**Re: Engineering Service – Traffic Access Study
Proposed Residential Draft Plan of Subdivision
1745 and 1775 Thorny Brae Place, City of Mississauga ON
Our Project No. NT-16-028**

NexTrans Consulting Engineers (A Division of NextEng Consulting Group Inc.) acknowledges receipt of City of Mississauga comments dated January 28, 2019, with respect to our Transportation Study, dated November 27, 2017. The intention of this letter is to address these comments attached in **Appendix A**.

Figure 1-2 – Revised Site Plan

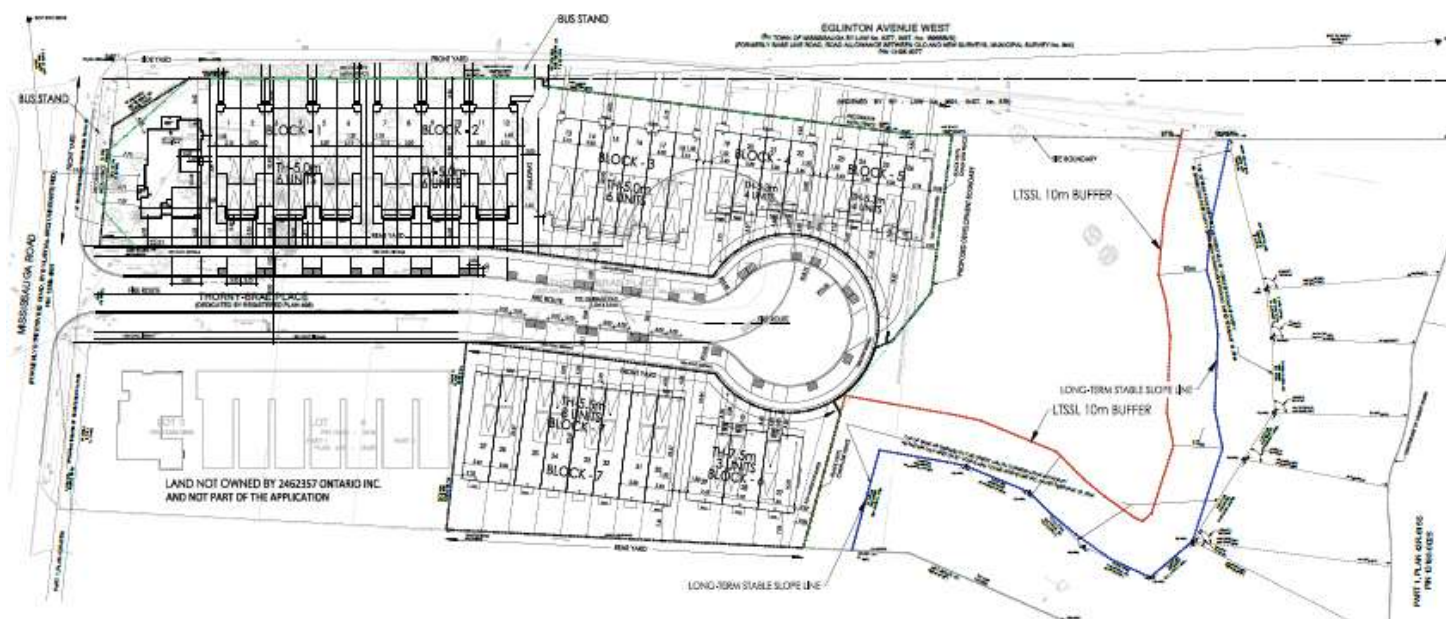
S8.0 – The report identifies a Site Circulation/Loading review with figure. Please expand on the review to identify details of the extended Thorny Brae Place right-of-way, including ROW width, and cul-de-sac details in accordance with specific City Standards. The apparent center island within the cul-de-sac should not be proposed.

Response: Based on Discussion with City of Mississauga Staff Giancarlo Tedesco, the site plan must adhere to this comment. As such, please see revised Appendix B site plan.
